## Edits and Additions to the Proposed Plan in Response to Public Comments

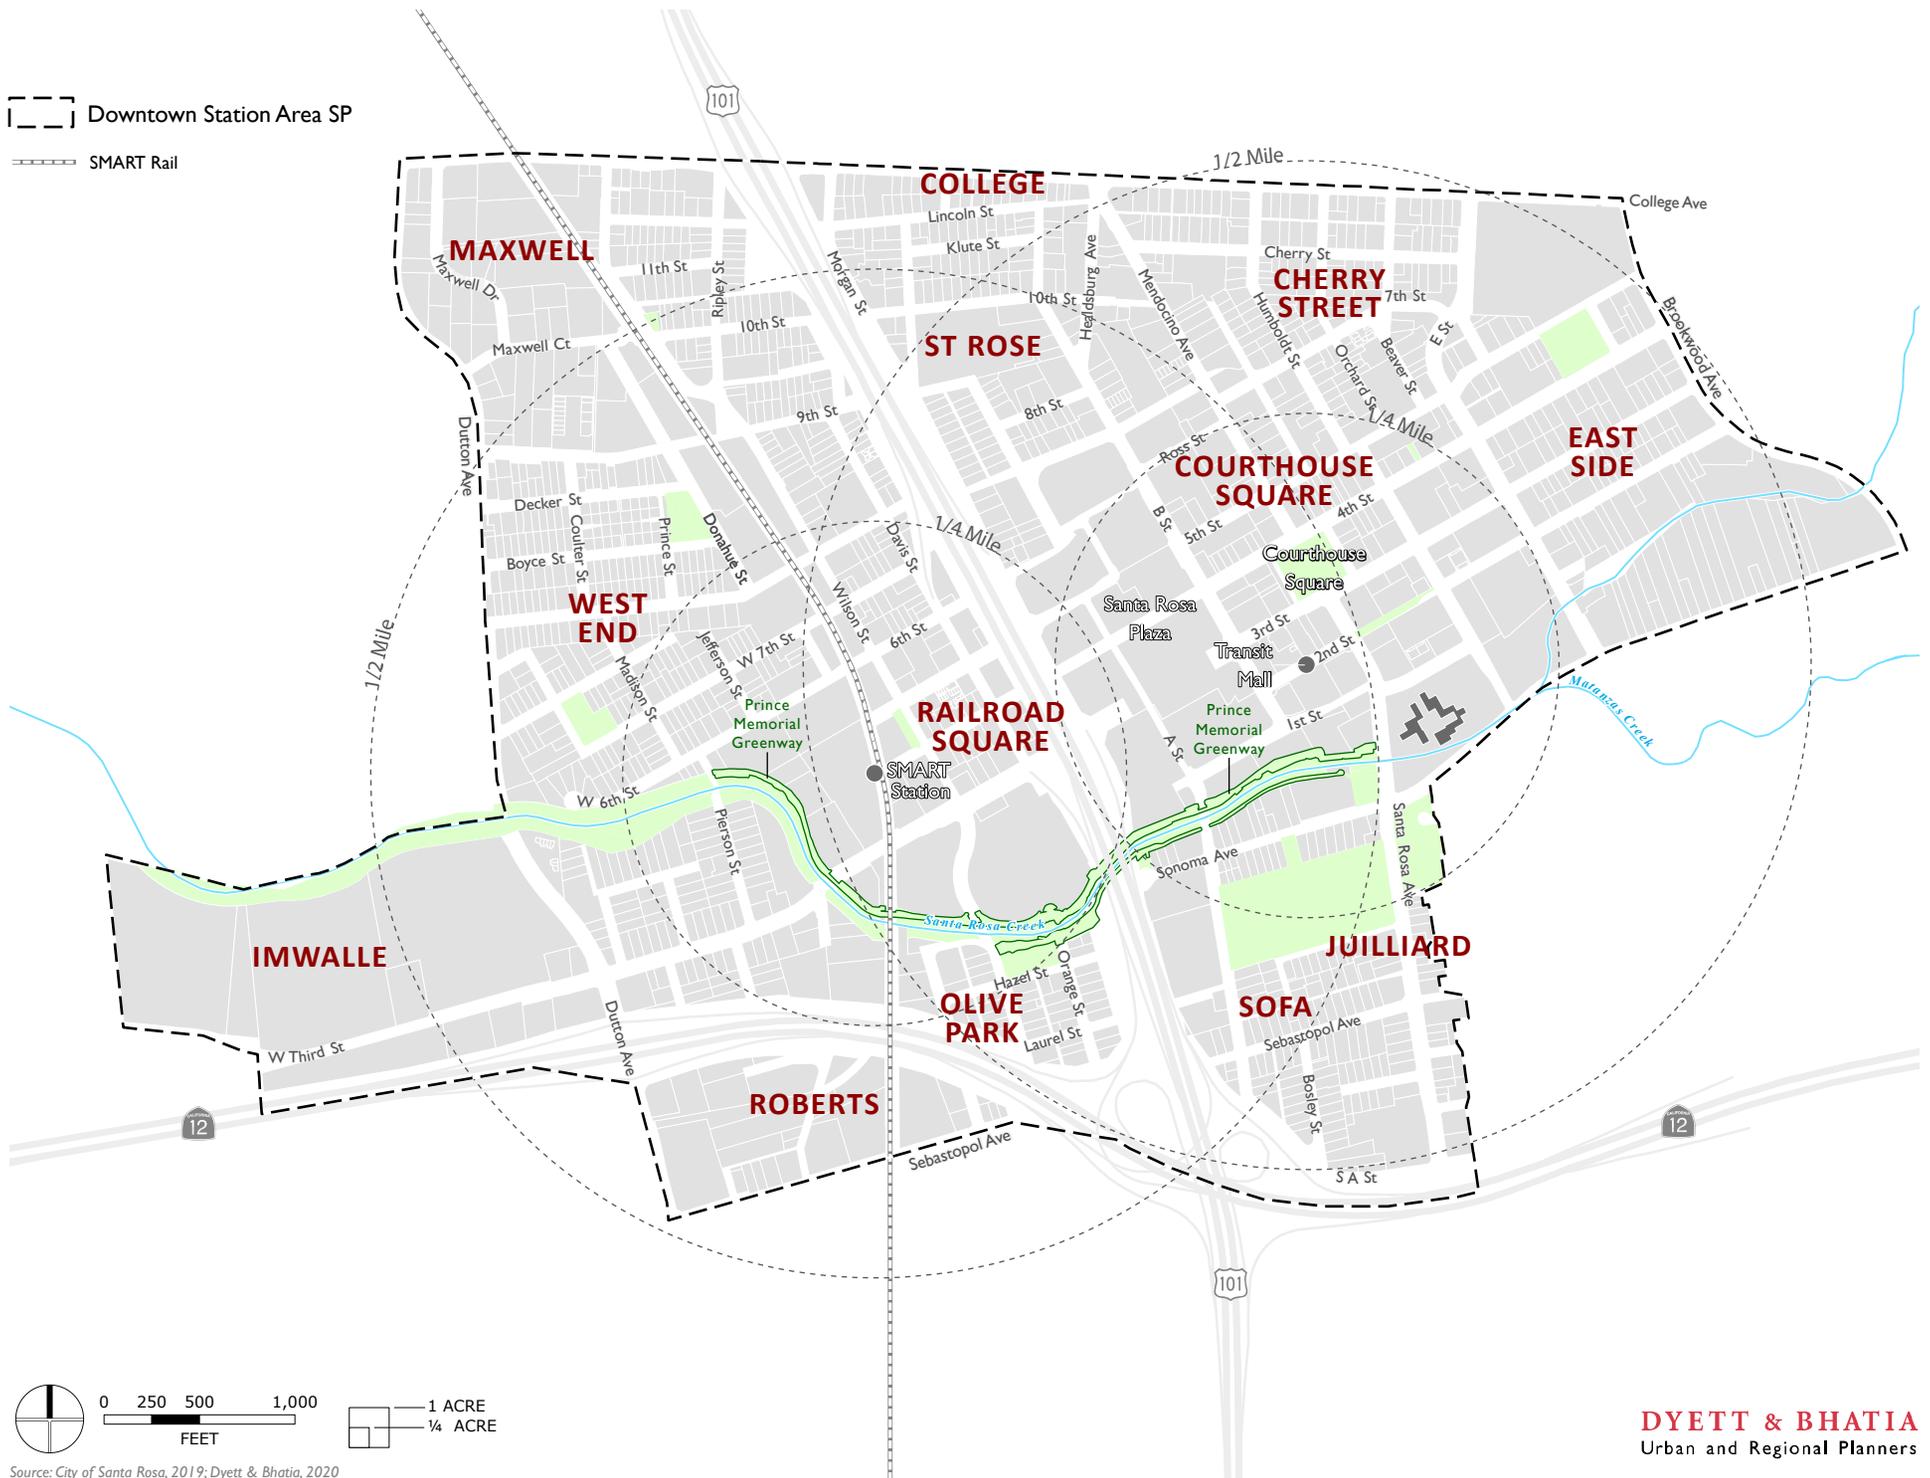
Introduction	1-9; 3-10; 3-11; 5-15	Keep consistent: <u>Citywide</u> Creek Master Plan
Introduction	Map Intro-1	Delineate Prince Memorial Greenway on Map INTRO-1
Land Use	2-2	Change Vacant Land description on Page 2-2 to state the following: Several large sites account for a large portion of this vacant land, including the SMART site west of the Downtown Station between West Third and West Sixth Streets and several properties in the <u>western portion</u> of the Downtown Station Area around Imwalle Gardens.

# LU-3: Land Use

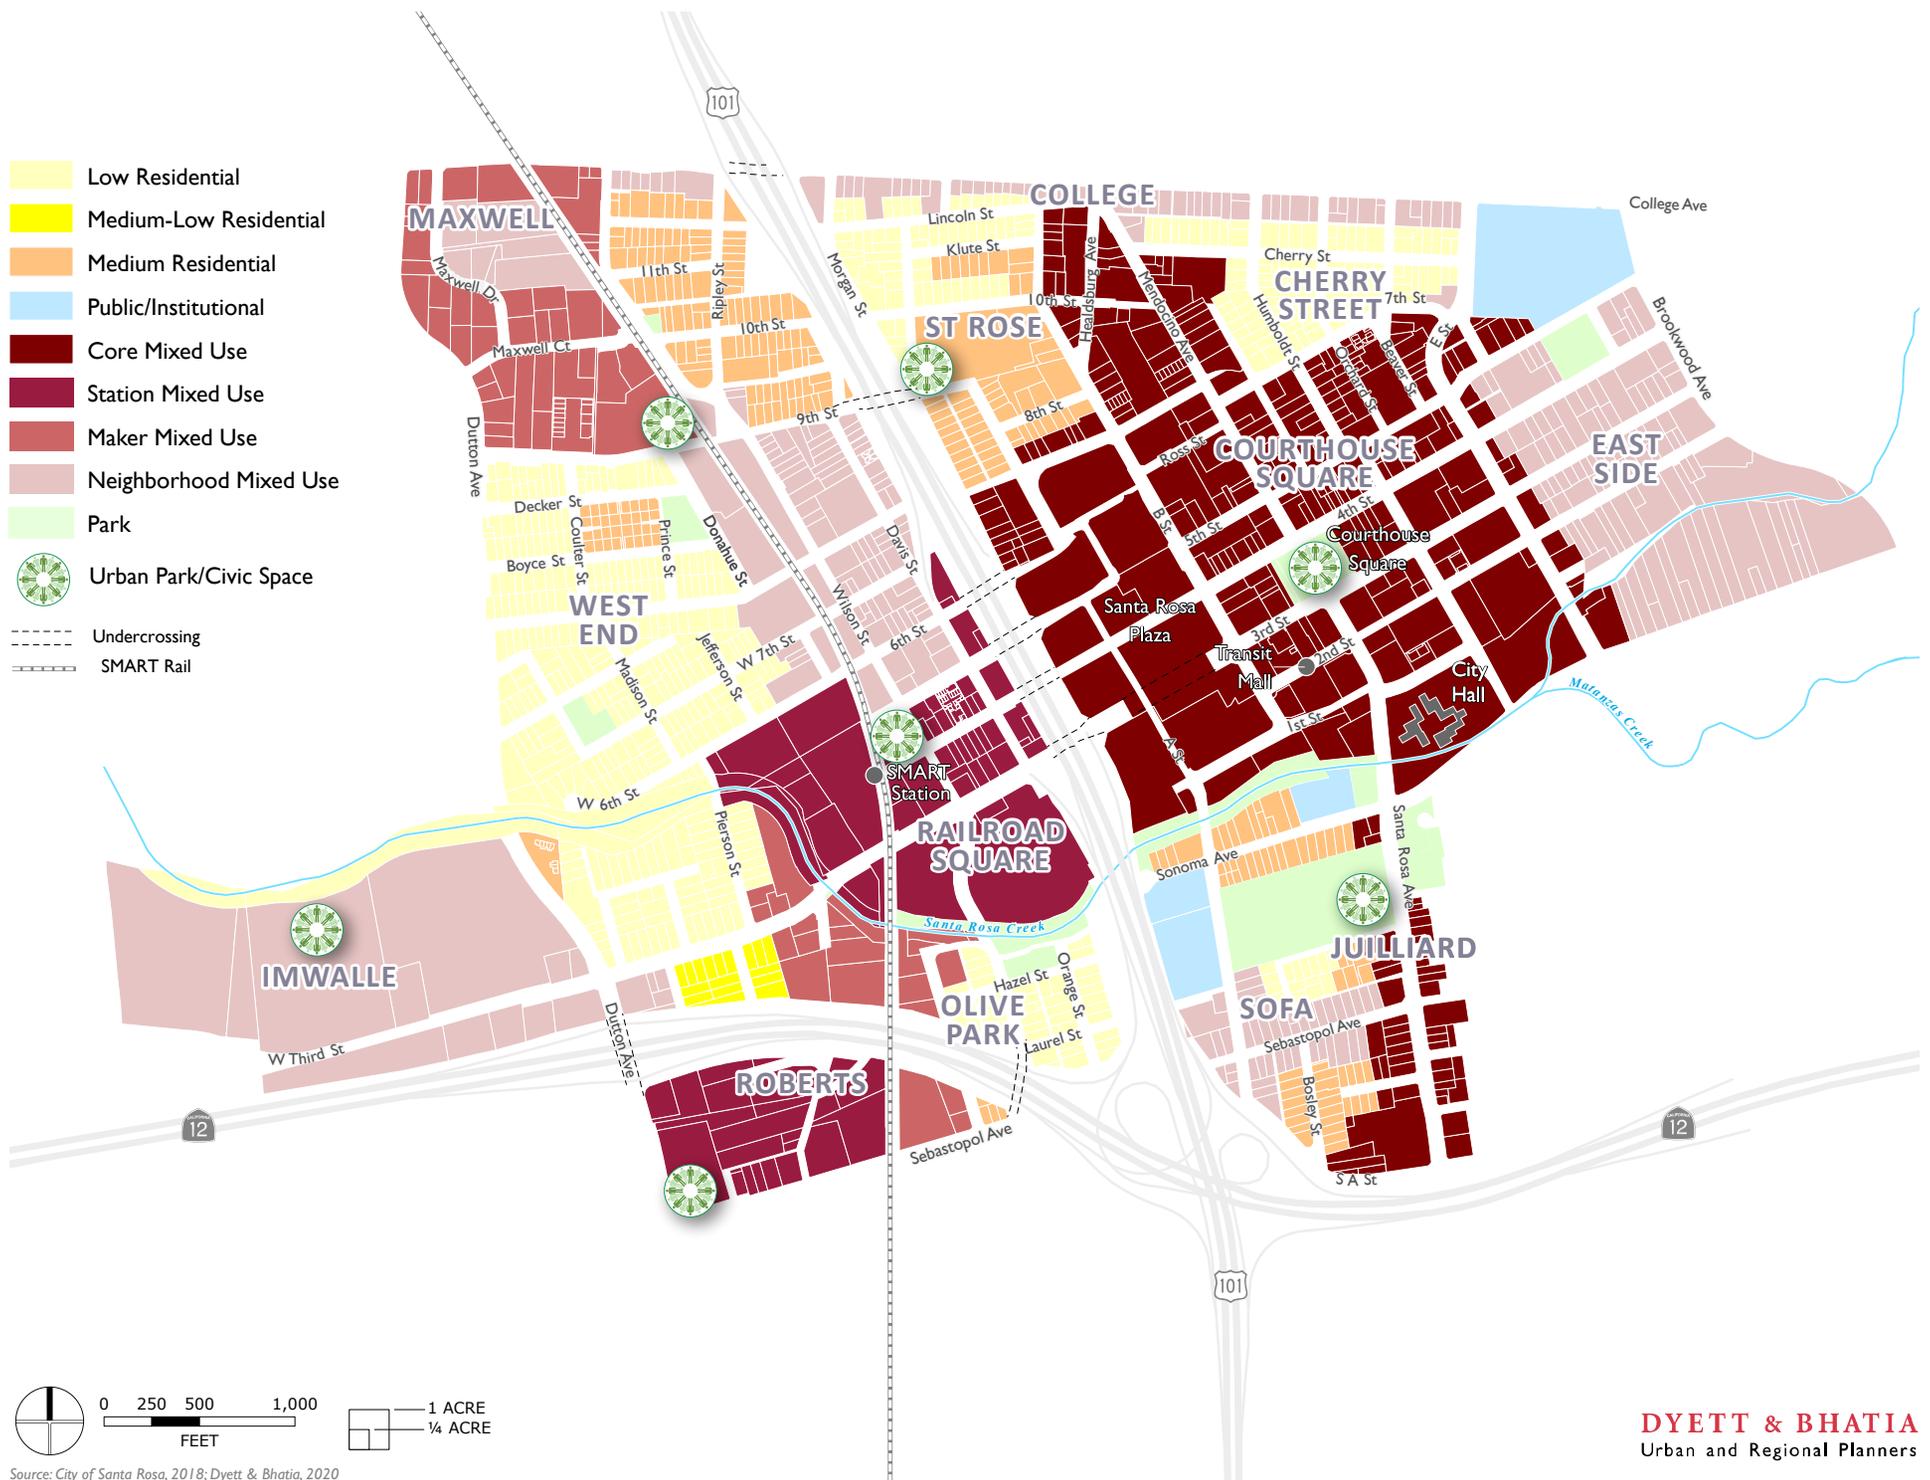
Land Use	Map LU-3, Map LU-5	Apply Neighborhood MU land use and max FAR of 2.0 for the properties on W. 3rd between Dutton and Decoe
Land Use	Map LU-3, Map LU-5, Map UDCS-1	Apply Core MU land use and max FAR of 4.0 for 526 Sonoma Avenue; add Neighborhood Transition to west-facing side of parcel
Land Use, Urban Design and Civic Spaces	Map LU-3, Map LU-5, Map UDCS-1	Apply Core MU land use and max FAR of 3.0 for two blocks on B Street north of Healdsburg Avenue up to Lincoln Ave. (Core Mixed Use - FAR 3). Add Neighborhood Transition to parcels fronting B Street.
Land Use	Map LU-5	Apply max FAR of 4.0 for one block on B Street between 7th Street and Healdsburg Avenue (Core Mixed Use - FAR 4).
Mobility	3-2	Replace "Vehicle Miles Traveled" header with "Performance Metrics"
Mobility	3-4	Edit Policy MOB-1.1 to clarify as follows: Maintain a roadway classification system as illustrated in Figure MOB-1, with the following segments as Boulevards designed to accommodate transit, bicycles, and pedestrian facilities together with vehicle traffic: * <u>Santa Rosa Avenue from Sonoma Avenue to South A Street</u> * <u>E Street from Sonoma Avenue to College Avenue</u>

# MOB-4: Planned Pedestrian Improvements

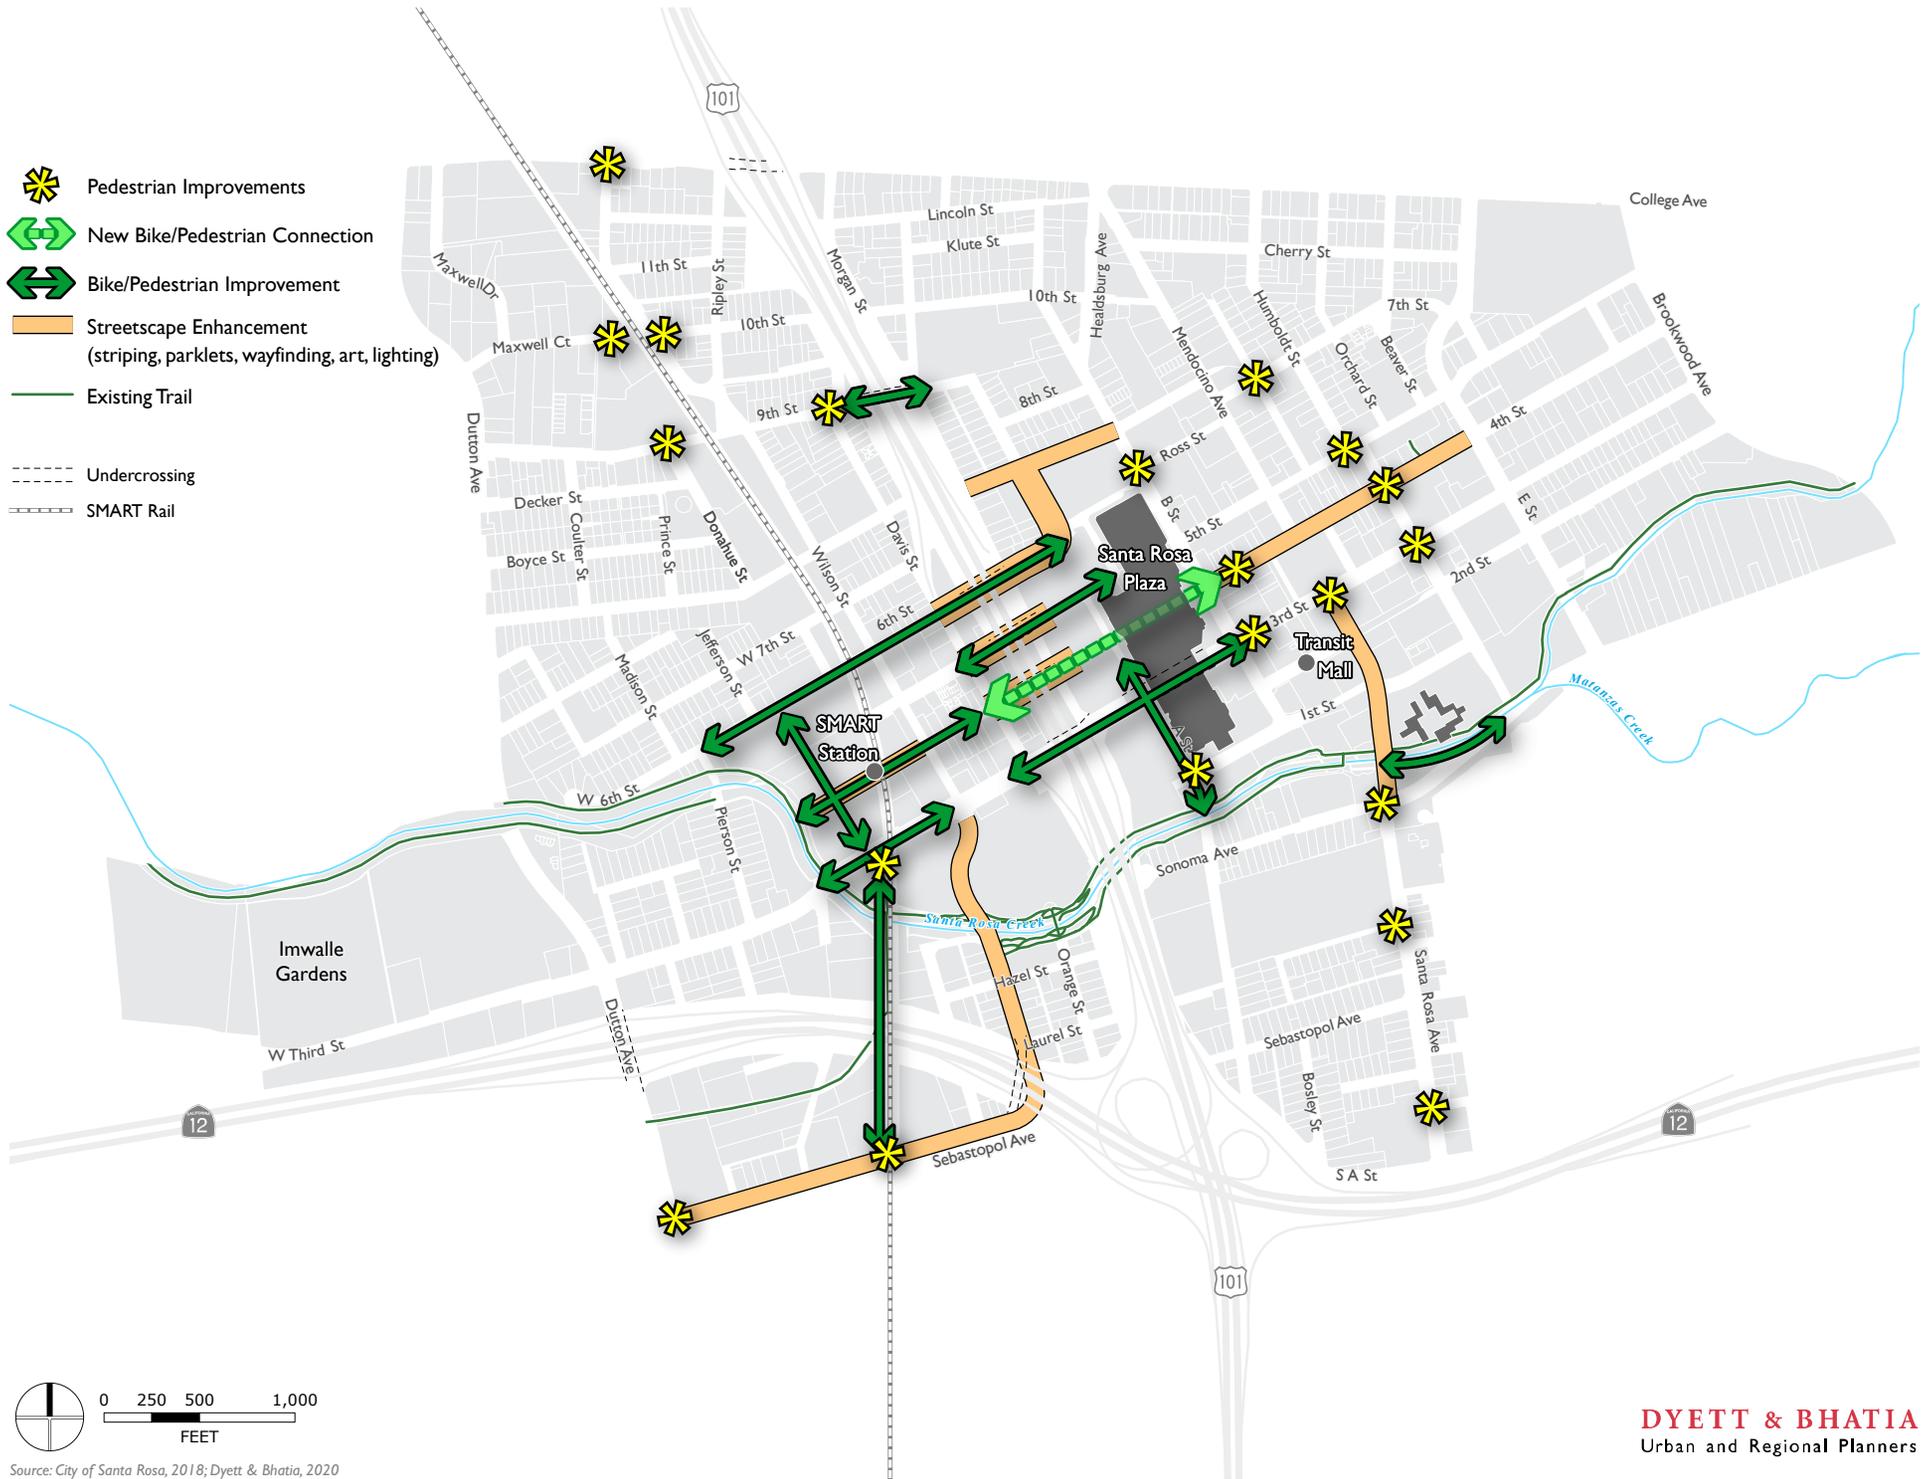
Mobility	3-24	Correction to MOB-6.4: Prohibit new stand-alone surface parking lots and encourage the <u>conversion</u> of existing parking lots to increase housing density.
Mobility	Map MOB-3; Map MOB-4	Show Class II bicycle facility on Map MOB-3 and MOB-4 between West Third Street and West Sixth Street through the SMART property
Mobility	Map MOB-3	Add planned Class II Bike Path to Brookwood Ave from 2nd Street to College Ave
Mobility	Map MOB-3	Add Trail Access Points at Imwalle, north of creek at Railroad Street, clarification that downstream of Pierson is a gravel path, and that daylighting can occur at both Matanzas and Santa Rosa Creeks
Mobility	Map MOB-4	Add a pedestrian improvements icon to Map MOB-4 at Sonoma and Santa Rosa Avenue (as envisioned in bike ped master plan)
Mobility	Map MOB-4	Show bicycle/pedestrian through-connection from Santa Rosa Creek to SMART station at 4th Street
Urban Design and Civic Spaces	4-3	DS-1, Revise bullet four to insert a comma between "on-site" and "or" so that a curbside parklet is not required to be a minimum of 600 feet.
